Rezoning Petition 2018-110 Pre-Hearing Staff Analysis April 15, 2019

PLANNING STAFF REVIEW

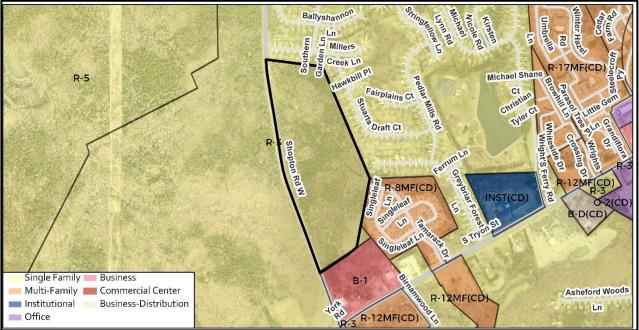
- 1. An updated transportation technical memorandum was submitted addressing CDOT and NCDOT comments on February 15, 2019. CDOT may have further comments once the review is complete.

- 2. Revise the site plan and conditional note(s) to show 2'-6" curb and gutter on Shopton Road West. The back-of-curb is located 32.5 feet from centerline of the road. The curb-and-gutter is a requirement of the Ordinance.

- 3. Remove "otherwise delay the connection" from note "7". The connection is required and cannot be delayed. The connection can stay closed to prevent construction traffic to access

- a. Staff will work with petitioner on item #2 to determine the best method to resolve that issue. Those options may include:
 - i. Providing the curb in its future location with a widening of Shopton Road West as a result

- ii. Providing the necessary right-of-way for the future widening of Shopton Road West
 - Providing off-site improvements as identified by staff and the petitioner's traffic engineer that would provide traffic improvements in the area of the proposed development
